Service Bulletin

Bulletin Number: **SB-20-338**
Release Date: **July 27, 2020**
Distribution: **Heil Dealers, Heil Technical Services, Heil Sales Team, Heil Customer Care**
Subject: **Half/Pack® (Featuring Odyssey® Controls): Pump-to-Valve 4-Wire Spiral Hydraulic Hoses Standardization and Hydraulic Hose Clamps Inspection**

Figure 1. CORRECT Use of Hose Clamps for Hoses

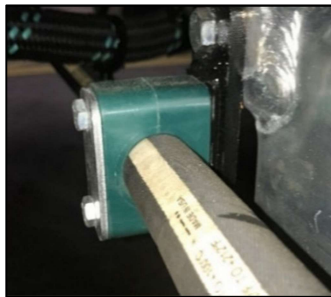
Hydraulic tube clamps should never be used on hydraulic hoses. Over time, these types of clamps will rub through the hose covering and potentially cause hose failure.

- (1) Inspect all hose clamps. There should be no daylight coming through between the hose and hose clamp. See **Figure 2** for an example of incorrect use of a tube clamp on a hose.
 - (2) Replace any tube clamps used for hoses with appropriately sized hose clamps. **The hose clamps must be tight and secure around the hoses.** See **Figure 1** and **Table 4**.
